# LINDSTRAND BALLOONS LTD

## SERVICE BULLETIN NO. 4

ISSUE 2 - DATED 12.03.98

<u>Title:</u>	MULTI-BURNER GIMBAL BLOCK
<u>Classification:</u>	Recommended
<u>Applicability:</u>	Jetstream Double + CLF, Jetstream Triple, Jetstream Triple + CLF, Jetstream Quad Burners.
<u>Serial Numbers Affected:</u>	019, 018, 028, 041, 070, 066, W/O 1129/1130, 165, 082, 101, 090, 074, 094, 090, 100, 135, 095, 188, 171, 190, 197, w/o 1808, 200, 249, 250, 297, 298, 307, w/o 3312, 311 312, 325, 235, 326, 334, 336, 300, 335, 345, 350, 358, w/o 3711, 377, 372, 378, 387, w/o 3724, 391, 326, 304, 409, 412, 413, w/o 14314, 421,317, 427, 431, 439, 445, 446, 447.
<u>Compliance Standard:</u>	Inspection to be achieved within the next 10 hours flying time.
<u>Background:</u>	The gimbal block shown in Fig SB4-001 and used on all the above burner types is designed to allow variable friction, independently on each gimbal axes by adjustment of four socket head cap screws on each axes. In one installation, sufficient friction could not be achieved due to the two faces of the block meeting. Subsequent adjustment of the four cap screws or weakening of the central block section has caused thread failure within the centra

FIG SB4-002. ORIENTATION OF GIMBAL BLOCK

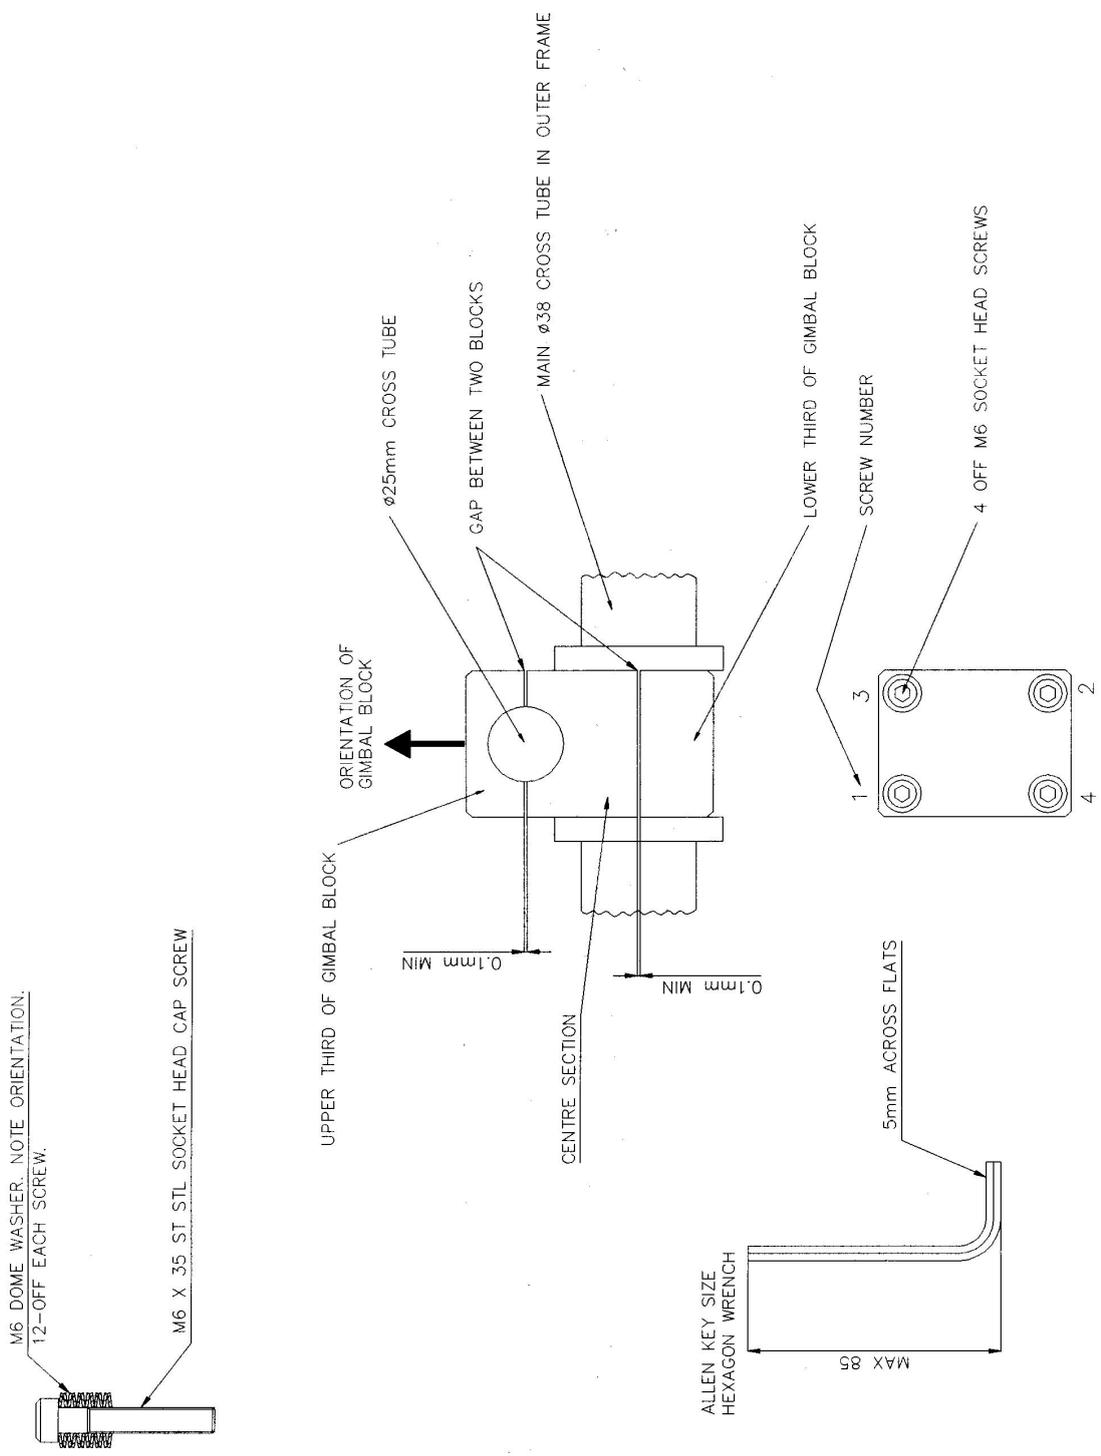
Both sides of the same gap should be equal and not less than those specified on Figure SB4-002. If the gaps are not equal, implement the procedure below.

If both sides of either gap are equal and less than those specified on Figure SB4-002, then a new gimbal assembly must be fitted. In this case, contact Lindstrand Balloons Ltd immediately.

If both sides of each gap are equal and greater than those specified on Figure SB4-002, then implement the following procedure:

1. Identify the screws securing the gimbal end cap to the centre section about the 25 mm cross tube.
2. Referring to Figure SB4-002:

Remove screw no. 1 using a 5 mm across flats Allen key (hexagon wrench), no bigger than that shown on the figure.

3. Apply Loctite 222 thread adhesive sparingly to the screw thread between 3 mm and 6 mm from the threaded end.
4. Ensure that the dome washers are assembled within the counter-bored hole of the gimbal block end cap, or over the screw, in the order shown on the figure.
5. Replace the screw in the hole and re-tighten using the allen key, until the screw is just nipped up.
6. Remove screw no. 2 using the allen key and repeat steps 3 through 5 inclusive.
7. Remove screw no. 3 using the allen key and repeat steps 3 through 5 inclusive.
8. Remove screw no. 4 using the allen key and repeat steps 3 through 5 inclusive.

For the Jetstream Double + CLF and Jetstream Triple burners, the gimbal block centre section is pinned to the 38 mm cross tube and thus no variation in friction is possible by adjustment of the gimbal screws. Fully tighten the screws in the order 1, 2, 3, 4 (see figure). For the Jetstream Triple + CLF and the Jetstream Quad burners, the gimbal friction is variable by adjustment of the gimbal screws. Repeat steps 9 through 10 inclusive, until the required gimbal stiffness is achieved.

Each side of the gap between the upper third of the gimbal block and the gimbal centre section should be equal and greater than the dimension specified on Figure SB4-002. Similarly, each side of the gap between the lower third of the gimbal block and the gimbal centre section should be equal and greater than the dimension specified on Figure SB4-002.

If after measurement, either of the gaps are less than those specified on Figure SB4-002, then a new gimbal assembly must be fitted. In this case, contact Lindstrand Balloons Ltd immediately.
